## PRODUCT CHANGE NOTIFICATION

**PCN:** PCN182407

**Subject:** Qualification of JEDEC Shipping Tray for 96 Ball VFBGA 6.0x6.0x1.0 mm Package

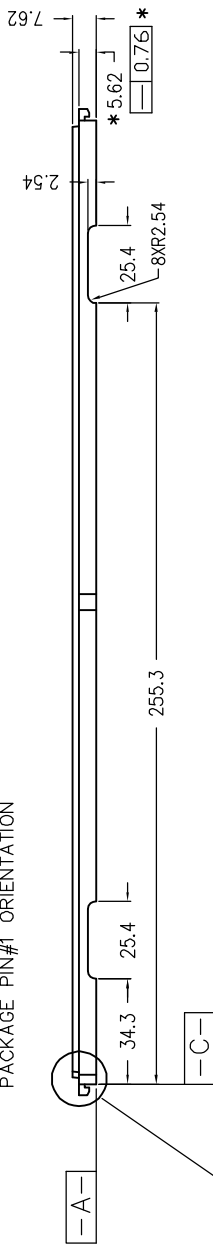
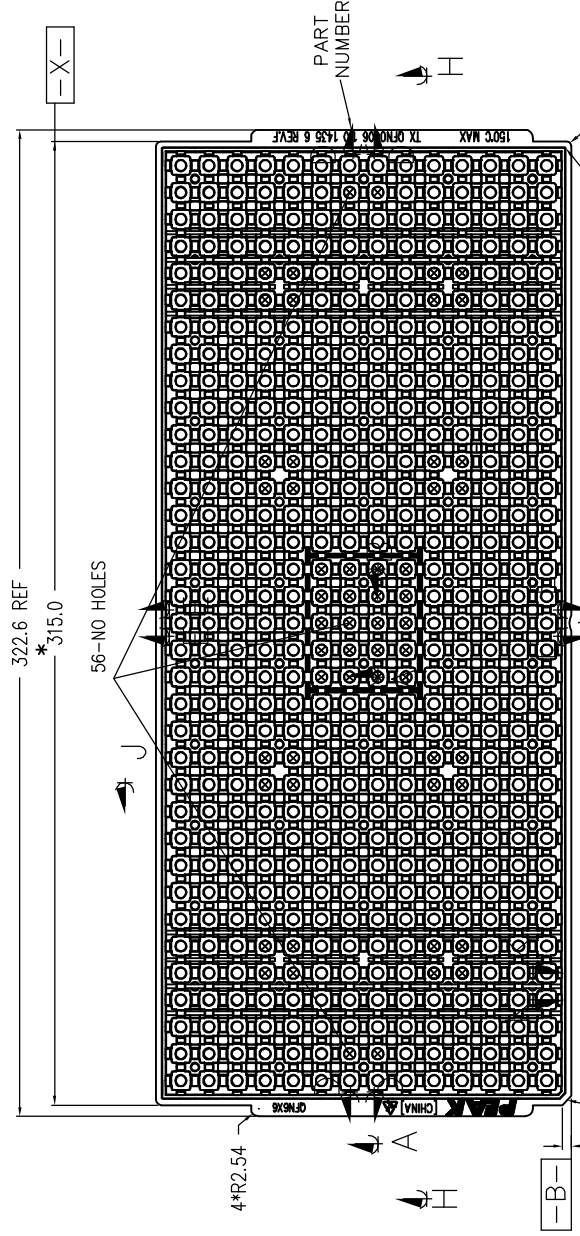
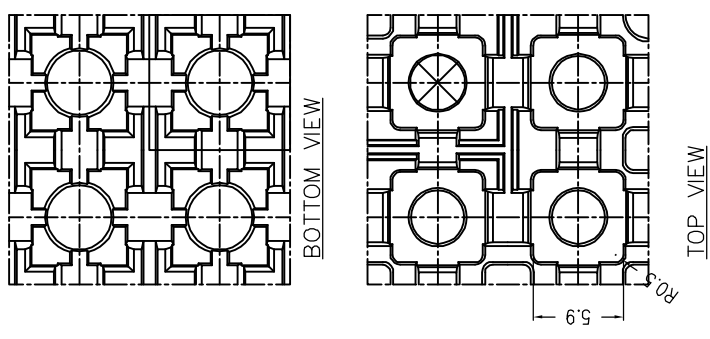
Cypress has qualified a JEDEC standard outline shipping tray for the 96 Ball VFBGA 6.0x6.0x1.0 mm package. The change increases the pocket density of the tray and minimum order quantity (MOQ).

The current JEDEC standard shipping tray with a 13 x 33 device matrix (429 units) will be replaced by a JEDEC shipping tray with a 14 x 35 device matrix (490 units).

Items	Current Tray	New Tray
Tray Manufacturer	PEAK	PEAK
Manufacturer Part No.	NH BG0606 1.5 1333 6	TX QFN0606 1.0 1435 6
Material Type	PP6	PP6
Number of Units/Tray	429	490
1 <sup>st</sup> Pocket X Position	15.90 ± 0.13 mm	7.90 ± 0.13 mm
1 <sup>st</sup> Pocket Y Position	15.45 ± 0.13 mm	8.15 ± 0.13 mm
Pocket X Pitch	8.85 ± 0.13 mm	8.80 ± 0.13 mm
Pocket Y Pitch	8.75 ± 0.13 mm	9.20 ± 0.13 mm
Top Pocket Length	6.20 ± 0.06 mm	6.25 ± 0.08 mm
Top Pocket Width	6.20 ± 0.06 mm	6.25 ± 0.08 mm
Package Seating Height	5.62 mm	5.87 mm
Minimum Order Qty (MOQ)	429	490

The change involved tray critical dimensions which will impact the pick and place equipment. Cypress recommends that customers review these changes against their current pick and place programs and equipment parameters.
